Submissions Report

AGL Dalton Power Project

APRIL 2012

Prepared for
NSW Department of Planning and Infrastructure
On behalf of
AGL Energy Limited
Level 22, 101 Miller Street
North Sydney, NSW 2064
43177661

Figure: 4-4

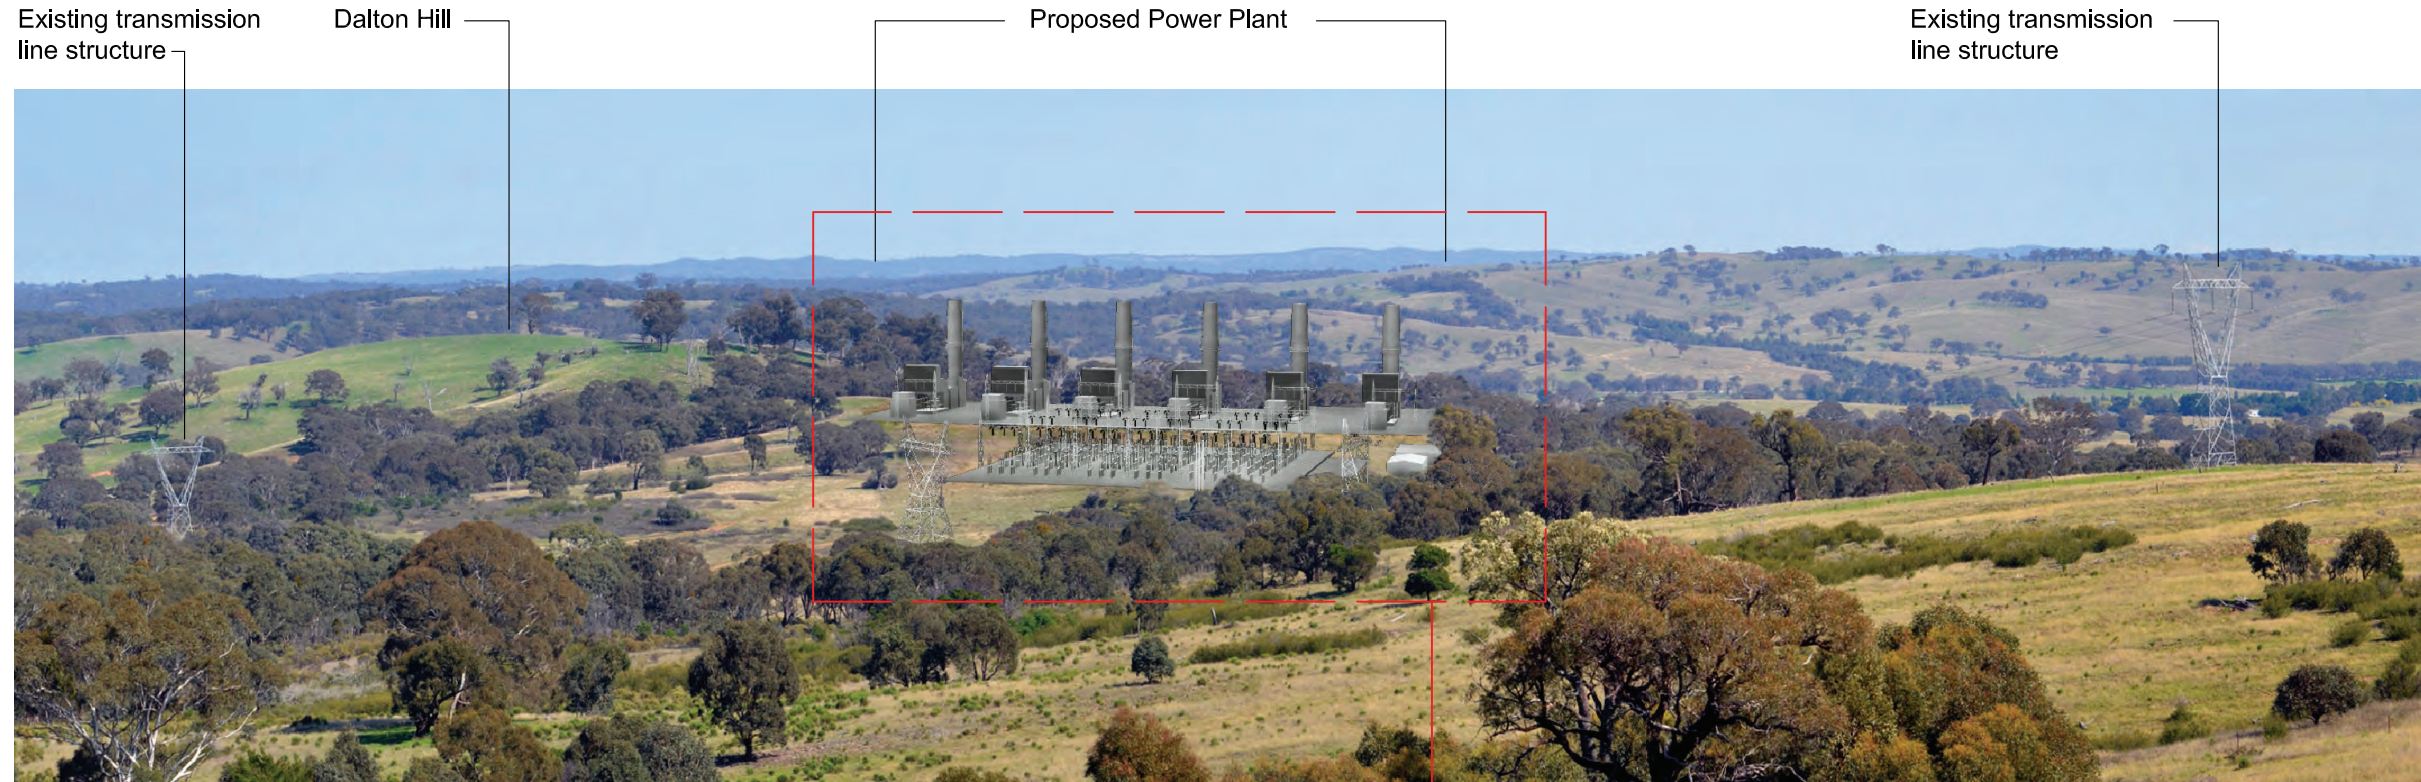
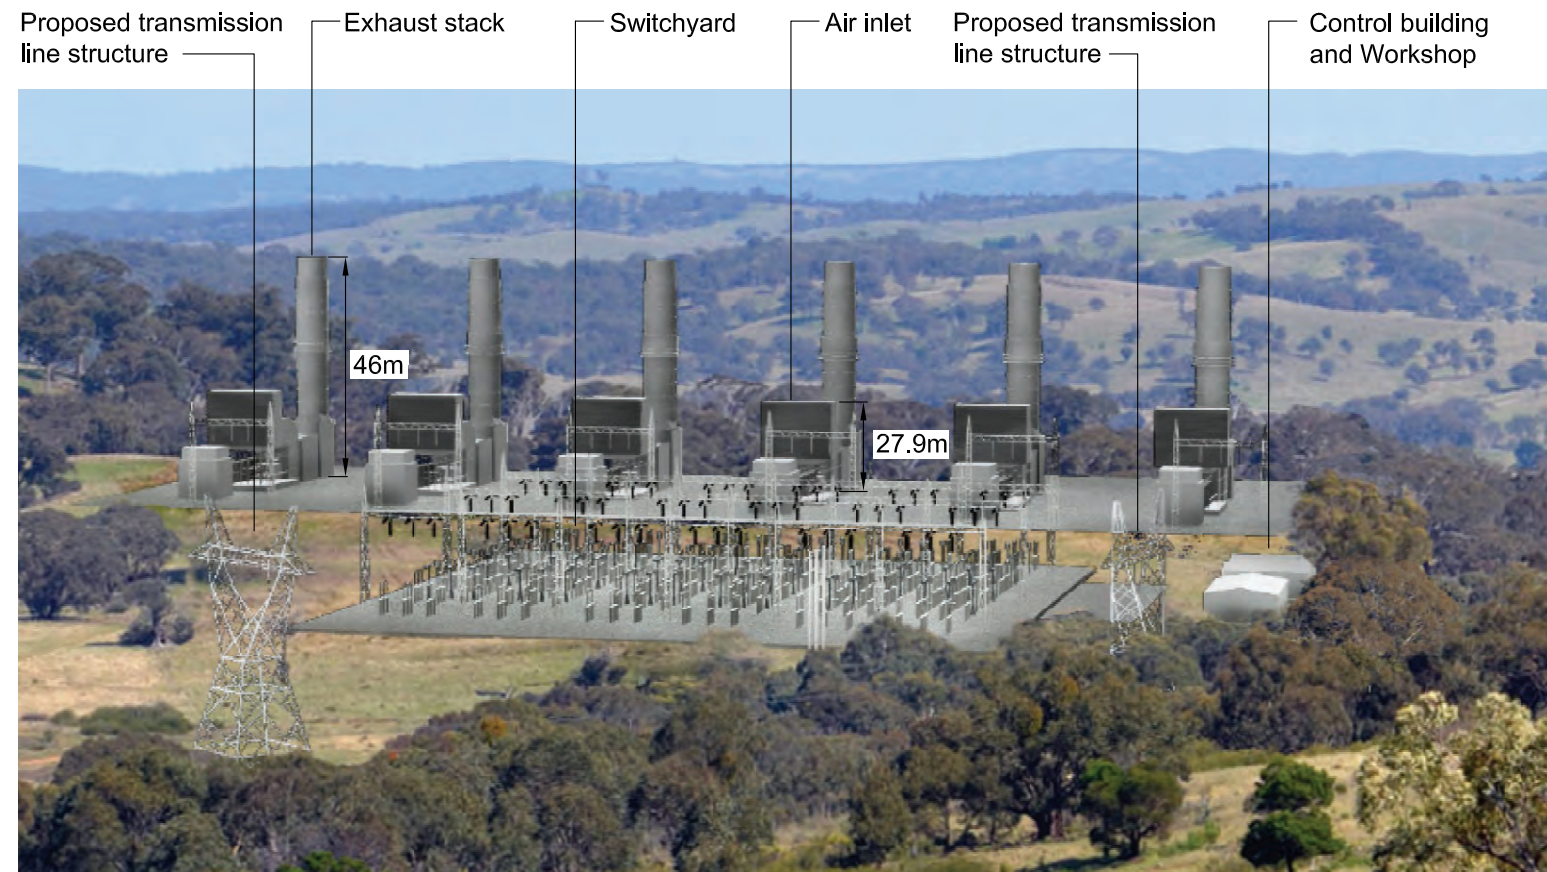
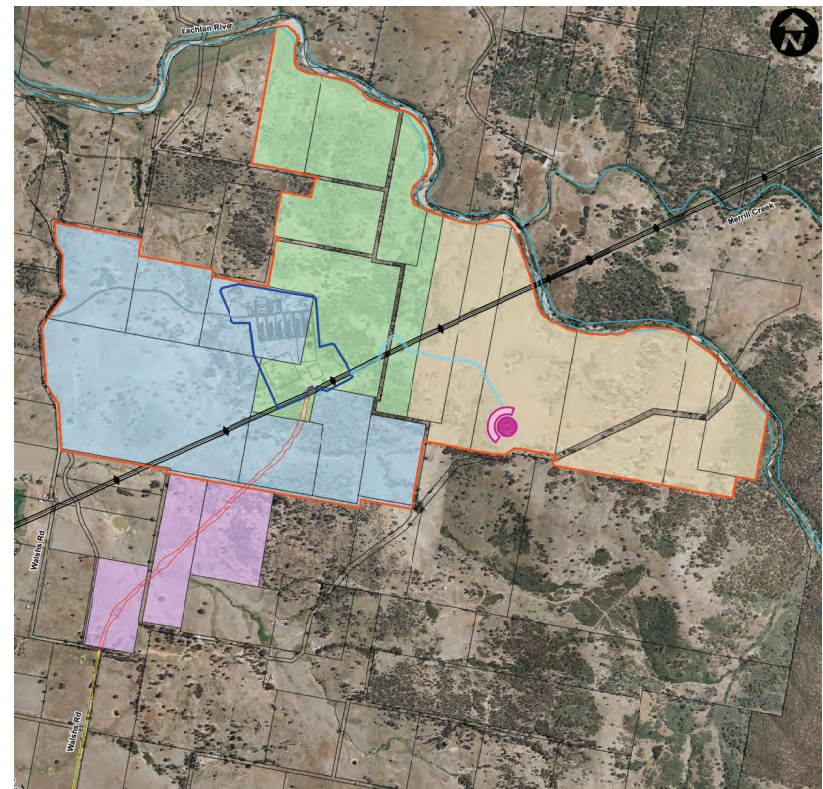
Since this issue has been raised within submissions, AGL has prepared a 3D model of the power station. The 3D model illustrates the facility and how it would appear in the landscape from within the AGL owned site. This representation is presented in **Figure 4-4**.
